<b>Title of Change:</b>	Change TO247 mold downset A1 remark position from lead tip to lead root for Automotive products.
<b>Effective date:</b>	20 Dec 2019
<b>Contact information:</b>	Contact your local ON Semiconductor Sales Office or Daisy.Zhi@onsemi.com
<b>Type of notification:</b>	This Product Bulletin is for notification purposes only. ON Semiconductor will proceed with implementation of this change upon publication of this Product Bulletin.
<b>Change Category:</b>	Assembly Change
<b>Change Sub-Category(s):</b>	Datasheet/Product Doc change

Example:

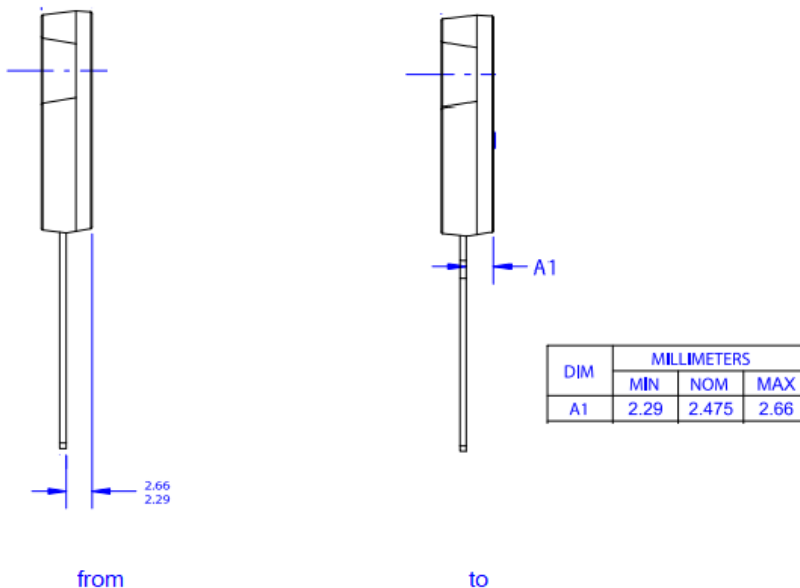
Change A1 remark position from lead tip to lead root, value no change.

Impact MOD are: 340CD, 340CF, 340CH, 340CJ, 340CK, 340CL, 340CU, 340CW, 340CX. This to follow ON standard drawing style and eliminate the confusion from internal and external.
